Facilities Access Compliance Survey Report for the Santa Clara Valley Open Space Authority

Santa Clara Valley Open Space Access Compliance Survey Report

13 1-1-1Facility: **Administrative Office**Part: **Interior**Floor: **First Floor**Address: **33 Las Colinas Lane**

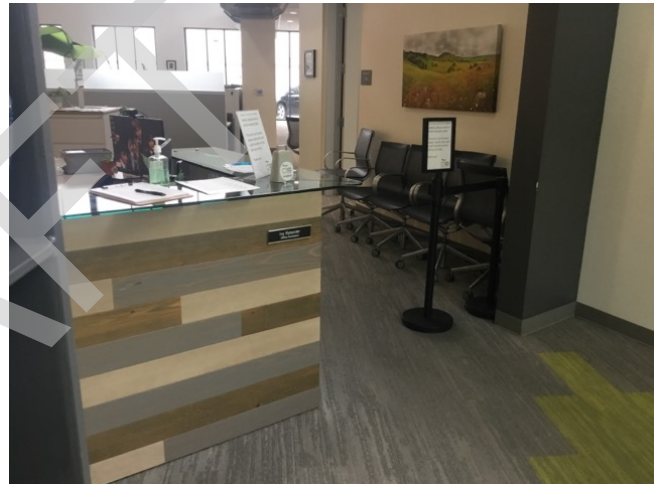
Provide cane-detectable railing to mark area of low clearance.

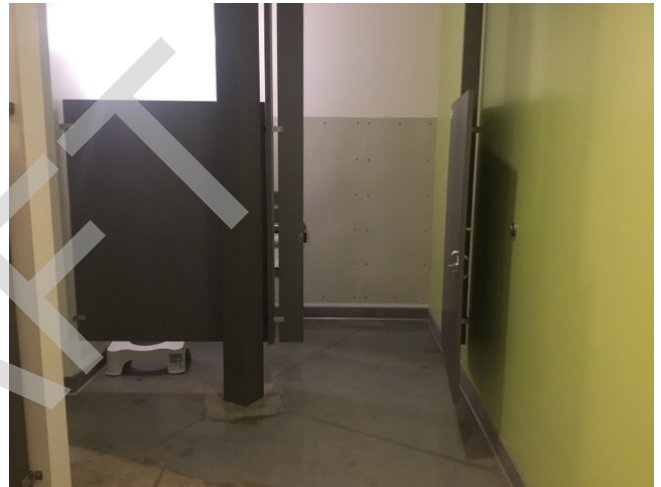
Relocate the compartment partition so the steel post is partially within the compartment or recessed into the partition.

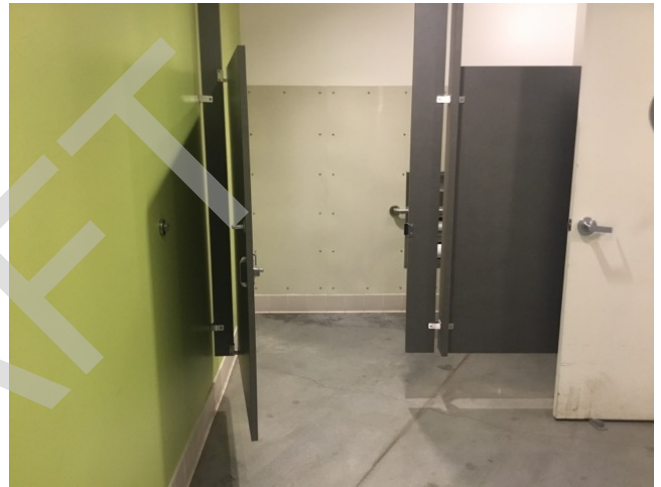
Provide properly mounted sanitary facility symbol when altering area. If wheelchair accessible, include International Symbol of Accessibility on sign.

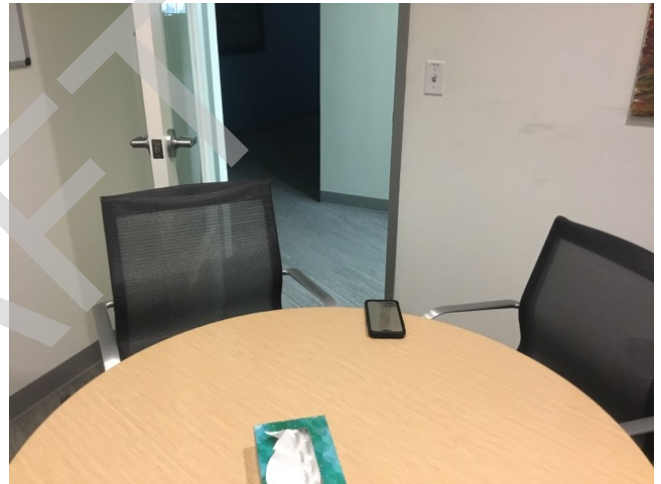
Remove or relocate furniture or storage items.

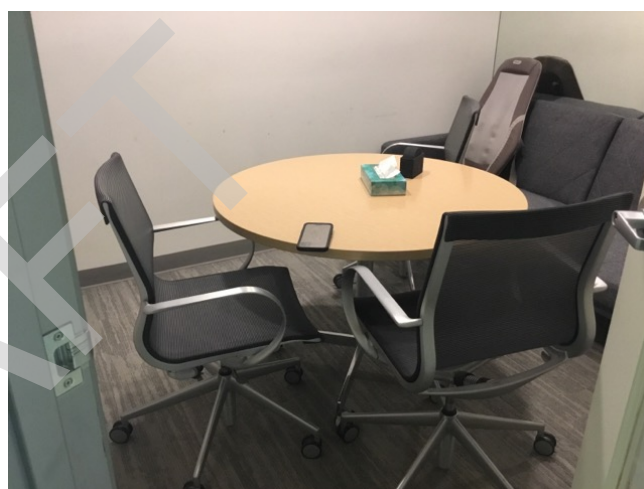
Accessible non-fixed table or desk (top 28" to 34" high; knee space at least 27" high x 19" deep x 30" wide) not provided.

• *As-Built:* **9" deep toe clearance.**• *Proposed Solution:*

Provide table or desk with accessible dimensions when purchasing new furniture.

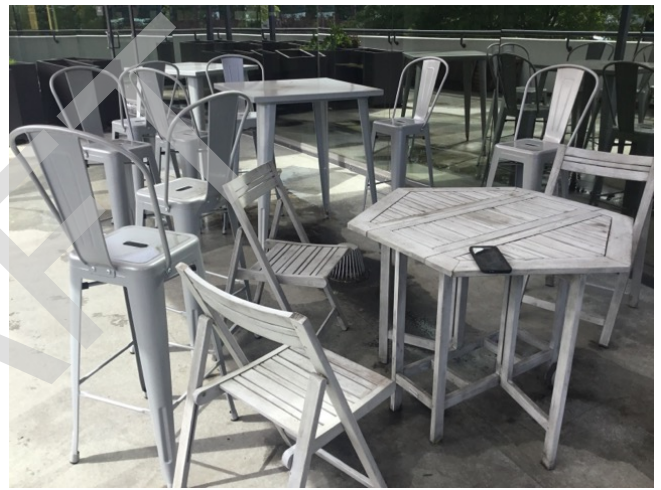
- *As-Built:* **41" to the top. 4" knee clearance.**

Provide table or desk with accessible dimensions when purchasing new furniture.

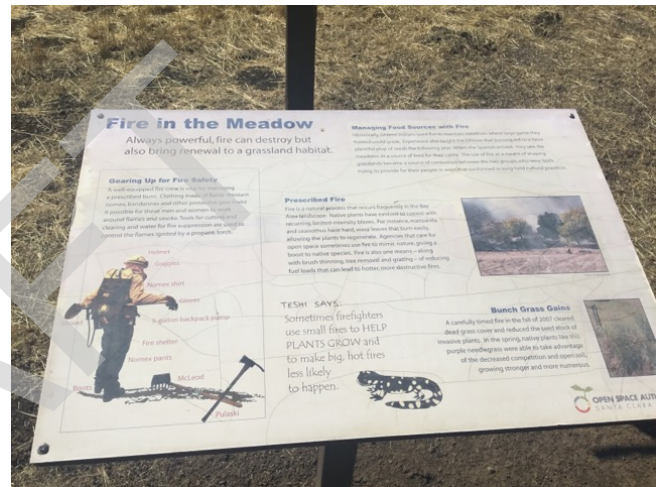
In addition there are characters with unusual font and the stroke thickness is approximately 10%. Occurs on signs throughout.

Provide compliant signage.
